Re: Contract N62470-89-D-4814
Navy CLEAN, District III
Contract Task Order (CTO) 0160
Response to Comments From: USEPA Region IV,
Risk Assessment Section, MCB Camp Lejeune, and
North Carolina DEHNR on the Draft RI/FS,
Project Plans for Operable Unit No. 7,
MCB Camp, Lejeune, North Carolina

RE: Draft Remedial Investigation Feasibility Study Work
Plan, Sampling and Analysis Plan, and Health and
Safety Plan for Operable Unit #7 (sites 1, 28, and
30)

North Carolina Superfund Comments
Camp Lejeune MCB Operable Unit 7 RI/FS Project Plans

FIGURE 8-1
EMERGENCY HOSPITAL ROUTE
SITES 1, 28, AND 30

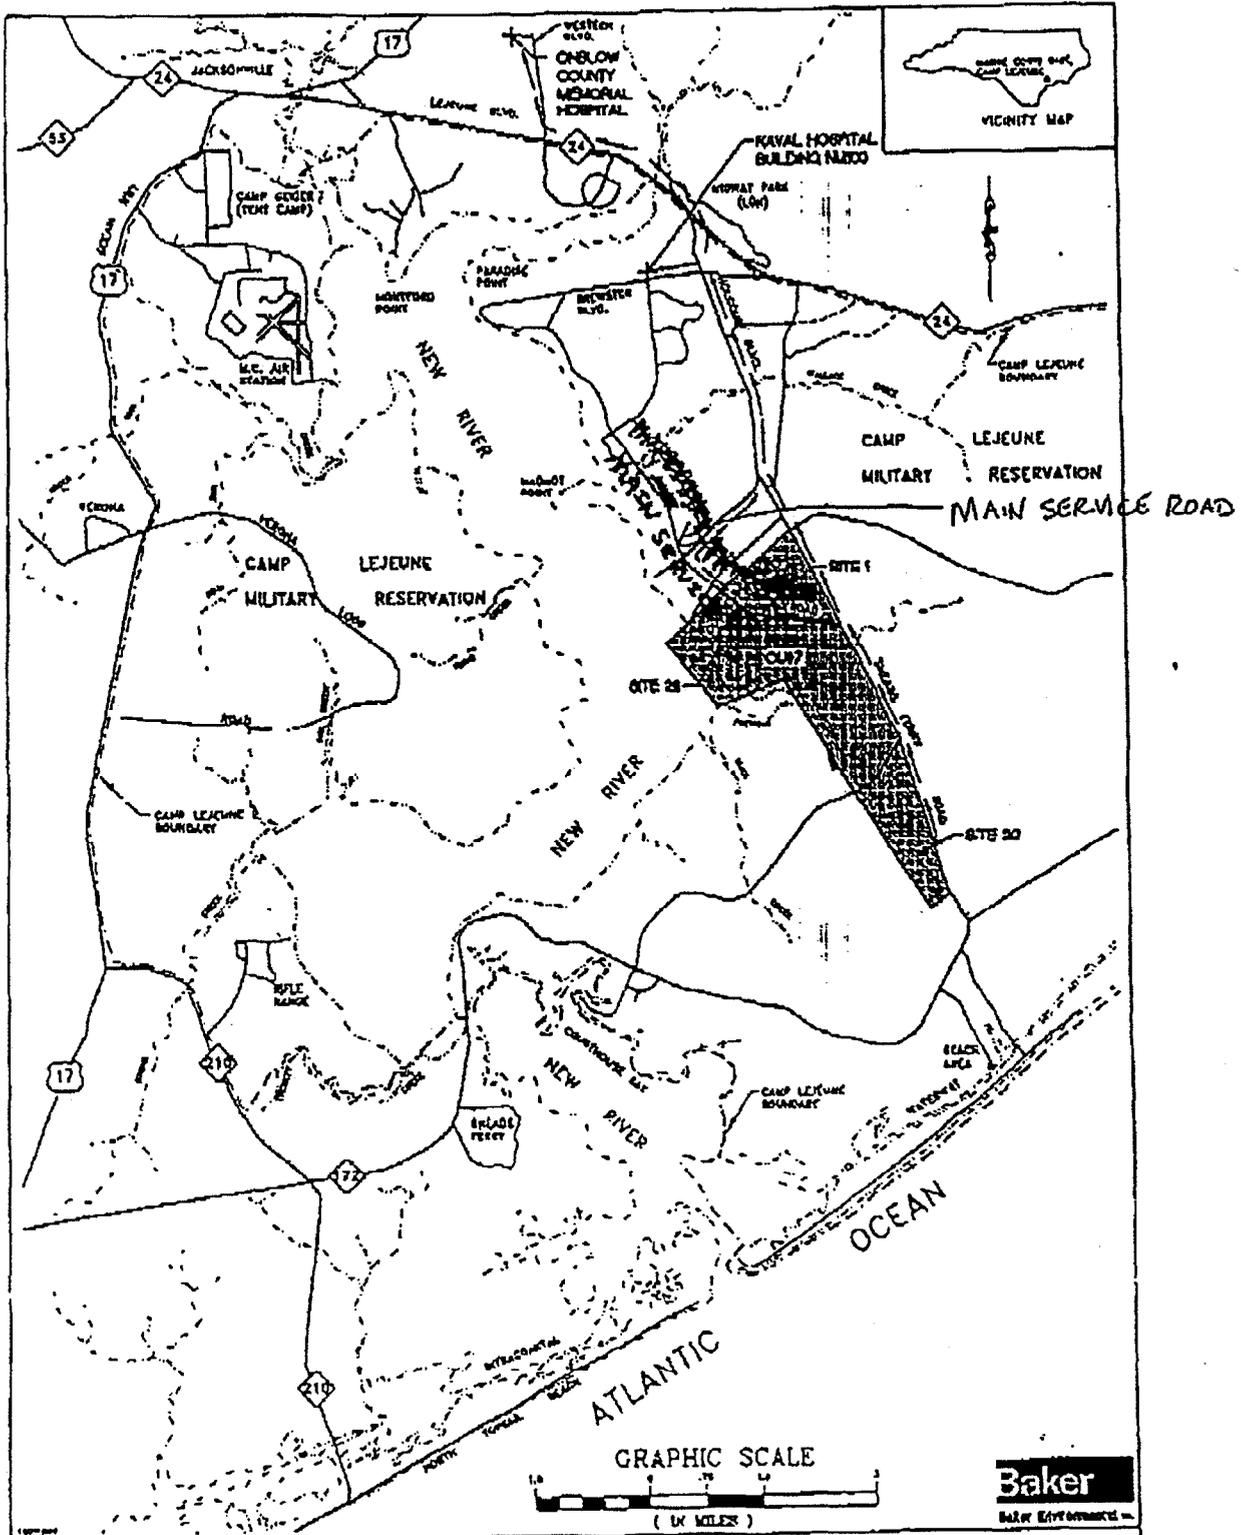
1. ~~Follow only exit road to W Street and make right turn.~~
2. ~~Follow N Street to circle and make right onto circle and another right onto Holcomb Boulevard.~~
1. FOLLOW EXIT ROAD TO JULIAN C. SMITH ROAD. TRAVEL ~~WEST~~ ^{NORTHWEST} ON JULIAN C. ROAD TO "O" STREET (FIRST STREET ON RIGHT) AND MAKE RIGHT TURN.
- MAIN SERVICE ROAD AND TURN LEFT.

ANOTHER RIGHT ONTO HOLCOMB ~~ST~~ BOULEVARD.

4. ~~3~~ Travel north on Holcomb Boulevard to ^Y traffic light and turn left on Brewster Boulevard.

2. ~~Follow N Street to circle and make right onto circle and another right onto Holcomb Boulevard.~~

2. TURN LEFT AND TRAVEL NORTH ON SNEADS FERRY ROAD TO HOLCOMB BOULEVARD AND BEAR RIGHT AT YIELD SIGN.

- ✓ 1. The names of the three Camp Lejeune EMD personnel, Mr. Neal Paul, Mr. Tom Morris, and Mr. Walter Haven, will be added to the table on Page 8-3.
- ✓ 2. Figure 8-1 will be revised to eliminate River Road.
- ✓ 3. The directions to the Base Hospital from Site 28 will be revised.
- ✓ 4. The directions to the Base Hospital from Site 30 will be revised.

FIGURE 1-1
LOCATION MAP FOR OPERABLE UNIT NO. 7
SITES 1, 28, AND 30
REMEDIAL INVESTIGATION CTO-0160

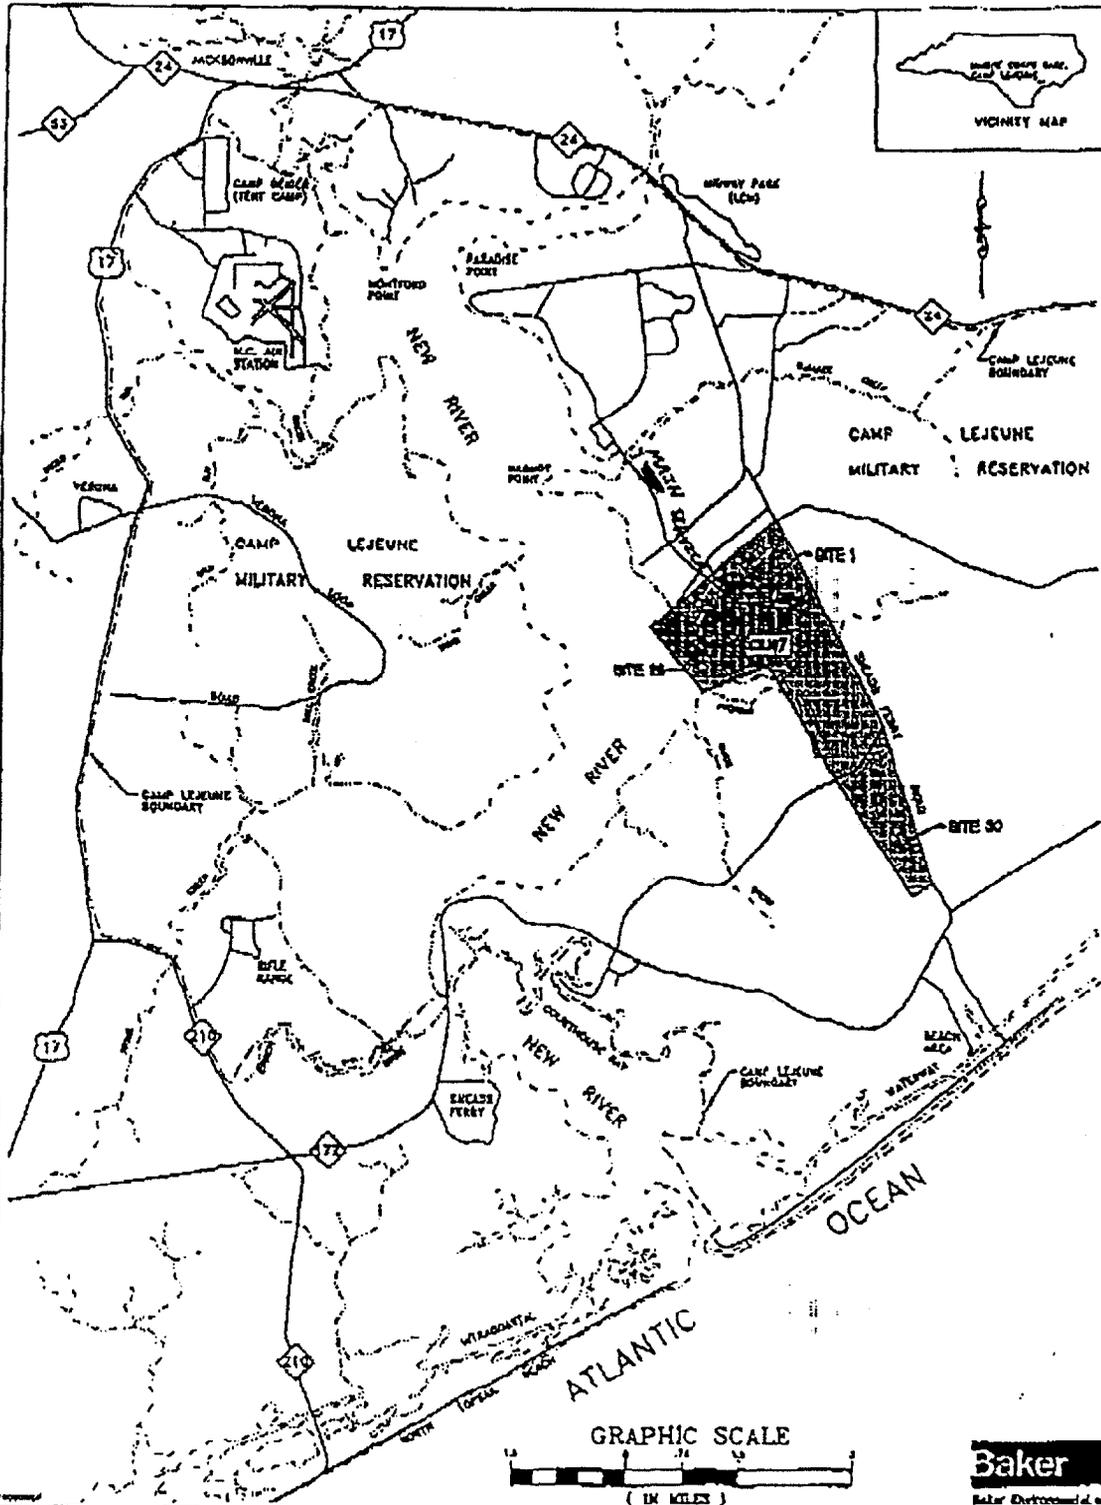
1. Figures 1-1 (Work Plan) and 2-1 (FSAP) will be revised to eliminate River Road.
2. The typographical error on page 5-32 in the Work Plan will be corrected.

*Eliminate
in WP 2-1
FSAP 1-1*
